3443 E. Lee Street Tucson, AZ 85716 August 4, 2016

I would like to bring the following issue to your attention regarding the water supply for the proposed Villages at Vigneto development. In March 2005, Errol L. Montgomery and Associates completed a study for the City of Benson on arsenic concentrations in city wells (figure attached). The results of that study would indicate that elevated arsenic levels will likely be encountered in the eastern portion of the proposed Vigneto well field. I have contoured the concentrations of arsenic in Benson City wells and projected them into the Vigneto well field area to illustrate this (figure attached). The current EPA limit on arsenic is $10 \,\mu\text{g/L}$ (10 parts per billion, red contour), reduced in 2006 from the prior limit of $50 \,\mu\text{g/L}$ (50 ppb).

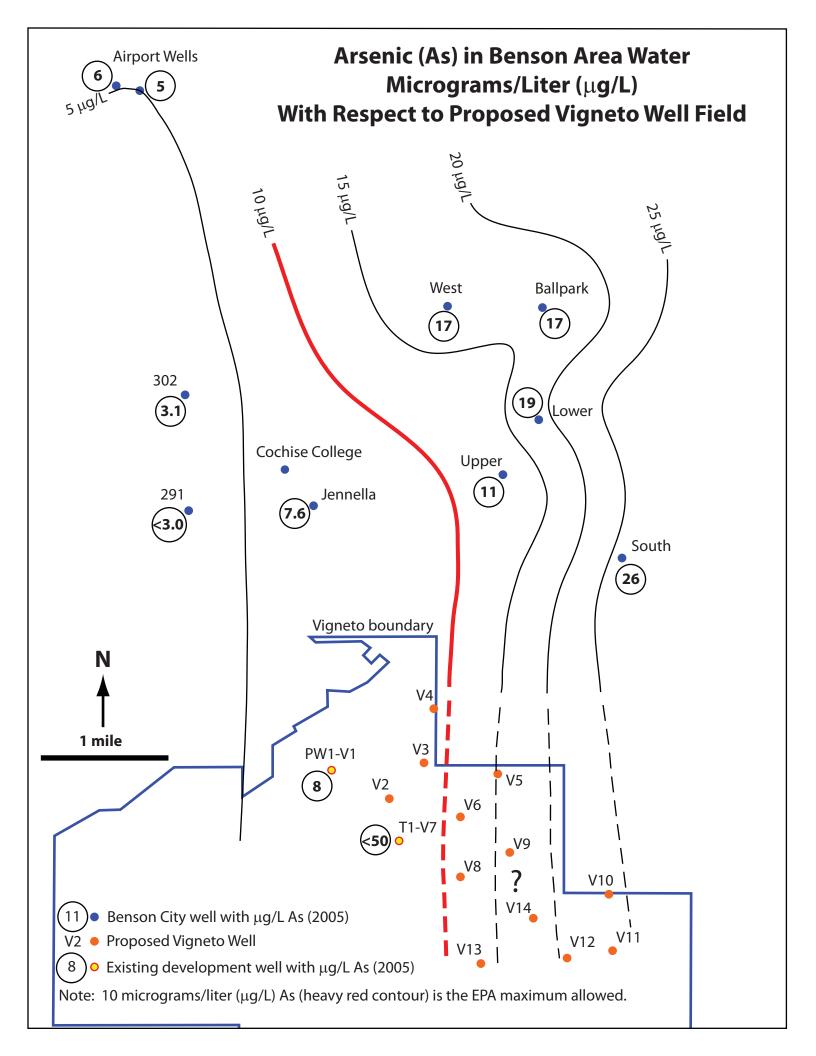
Of concern is the 8 μ g/L (8 ppb) level in former Whetstone Ranch Production Well 1 (PW1), which would be Vigneto's initial production well. Data from city wells indicate that arsenic in groundwater increases to the east across the Benson area, presumably because of the increased influence of groundwater coming from the Upper San Pedro basin that has passed through mineralized areas. Production well PW1 is at the far west end of the proposed Vigneto well field, making it probable that arsenic in the eastern portion of the field would exceed the EPA standard.

This possibility needs testing to determine potential limits on Vigneto's water supply. Well T1 (ADWR # 55-543338), which would be Vigneto production well 7, should be tested first. The $<50~\mu g/L$ value for this well indicates that it was evaluated under the prior EPA arsenic standard and has not been reevaluated under the new standard. Second, test wells should be drilled to the east of this well, most importantly at the far eastern end of the proposed well field, to determine the arsenic gradient across the field. These tests should be completed before large-scale construction begins in case arsenic concentrations require modification of Vigneto's design and scale.

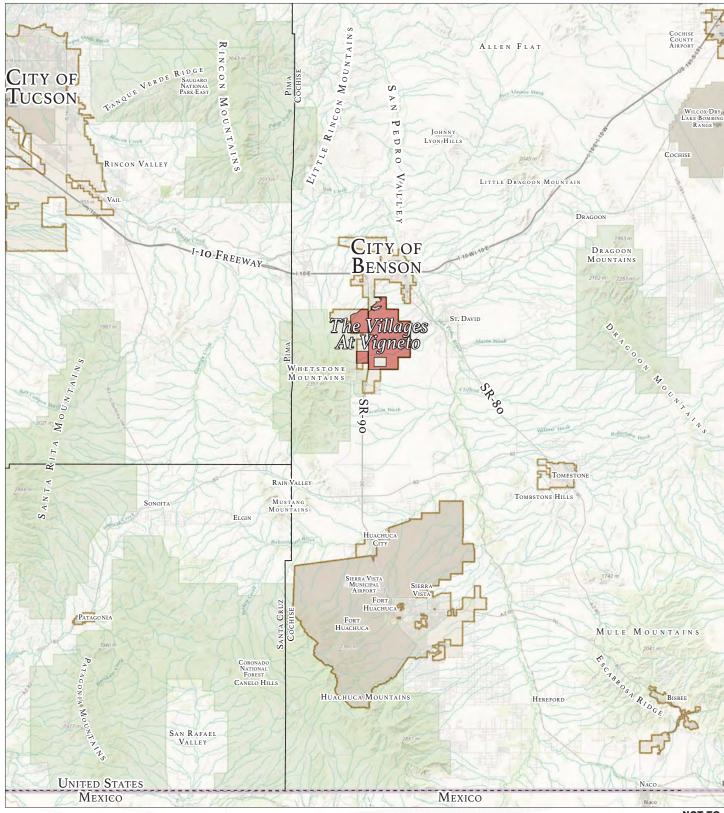
As you may be aware, El Dorado Holdings, LLC is proposing to build the Villages at Vigneto development on the west side of Benson (map attached). This development would encompass more than 12,000 acres and include up to 28,000 homes, bringing 70,000 people to Benson over the next 20 years.

You may also be aware that Benson-area water has a high arsenic content and that Benson had to abandon its central well field in 2006 and move its water supply to the west to comply with the new EPA arsenic standard (10 μ g/L). The proposed Vigneto well field would likely encounter the same problem. I am including a letter to Benson city officials with figures illustrating this.
